Macomber and Pimental Field

Town of Fairhaven ADA Transition Plan

November 2024

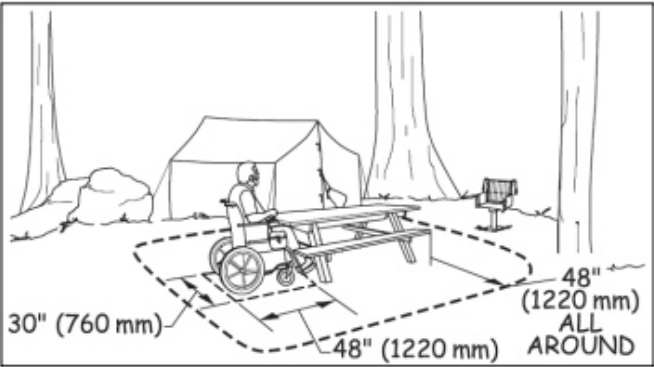
- Recommend providing a stable, firm and slip-resistant surface that is 48" clear on all sides of all provided accessible picnic tables, in a manner that is substantially similar to what is shown in the following image.

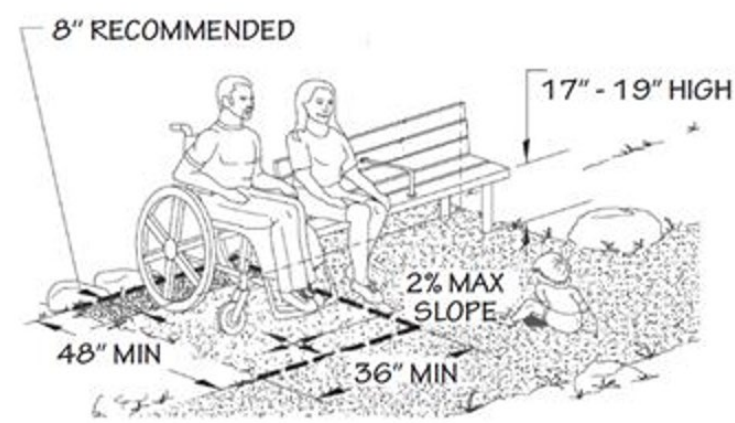
- Recommend providing a 36" min. by 48" min. stable, firm and slip-resistant surface adjacent to at least one bench in each area where benches are provided positioned to allow a person in a wheeled mobility device and a person sitting on the bench to have their shoulders aligned in a manner that is substantially similar to what is shown in the following diagram.
